Response to Comments

Project Name: English Crossing Townhomes

Project File Number: PA23-012

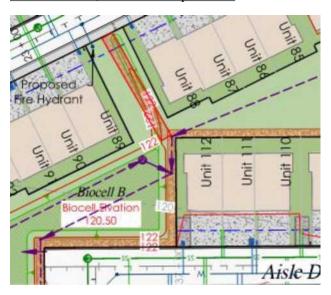
5. Pedestrian connections are required from entries of the units adjacent to 19th Avenue (Units 175-190, and 222-232). Installation of stairs will likely be needed to address the grade change. These connections shall be depicted on the site plan. This is a code requirement and is expected to be a condition of approval.

Issue due to some bad examples of the alternative. We are proposing a stair and sidewalk for each building.

Due to slopes on 19th, a bioswale is the only feasible way to convey stormwater along 19th. Having 26 sidewalks crossing that bioswale would compromise its effectiveness.
